ADDENDUM

Project: Grant 1,2 Parking Lot Expansion

Project No.: 519-2528

Addendum No.: One

FOR USE WHERE WATER DRAINS AWAY FROM CURB

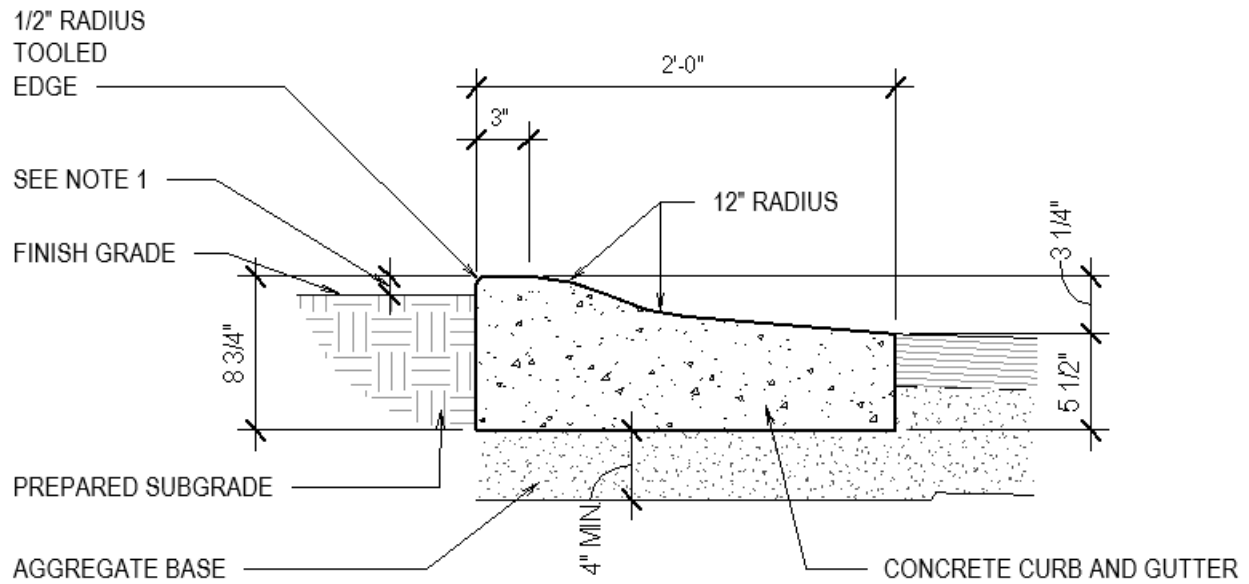
1. Entire length of Northern curb that runs East to West along the back of the new parking lot shall be a roll back style curb to match adjacent existing curb. See attached detail 14/SD1.2
2. Sidewalk being indicated by Keynote #7 shall be 6'-0" wide.
3. Keynote #11 shall be updated to read "Install 4 solar-powered light bollards – Meteor SP-8, Black, Surface Mount." The 4 light bollards shall be mounted on the sidewalk, eliminating the need for Detail 3/SD1.2. Contractor shall verify final location with Owner/Architect prior to installation.
4. Existing landscape island (located between the existing parking lot and new parking lot) to be re-graded and receive new sod as required to meet new top of back of curb elevations.
